FIELD SERVICE BULLETIN

FSB Number: LVCCFSB2004-7
Author: Tony Bryan
Date: February 1st, 2004
Total No. of Pages: 3
Subject: **GSM Triplets - SEC TMR Display Module**
Model Affected: V303, V400, V500, V525
Level of Repair: 3

Figure 2.0 – Date/Lot Code Identification

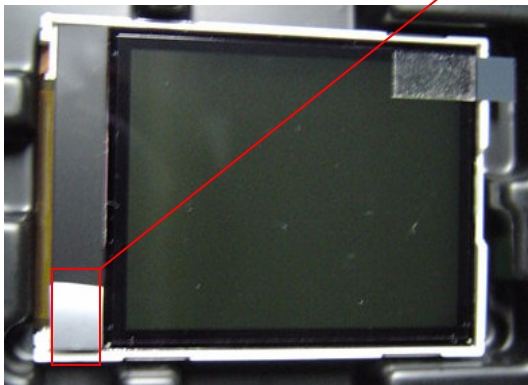
The original design of the Samsung TMR Display Module (7289238N02) had a high susceptibility to Gate Block failure due the overlapping of the ITO and Data Metal layers. Samsung Changed the design of the TMR Display module, as of November 1st, 2003, to a new mask to separate the ITO and Data Metal layers of the display and strengthen the over-all tolerance against “Gate Block” failure. Samsung TMR Display Modules (7289238N02), built on Line 1 prior to November 1st, 2003, are highly susceptible to this defect. See Figure 2.0 below.

Samsung has managed 2 FAB lines and 2 types of 1.88 inch product have been manufactured. In order to identify the FAB code of each product, you have to inspect the red square below picture shown with a micro-scope after detaching the black tape on the driver IC.

***Affected Date Code Range: CMH thru CMJ**

All affected date codes of the 7289238N02 Samsung TMR Display Modules should be removed from inventory and quarantined. See Figure 2.0 above for Date Code Identification. There is a possible opportunity to return affected material to the supplier for cost recovery. An updated version of this FSB will be released once the process for the disposition of this material has been identified.
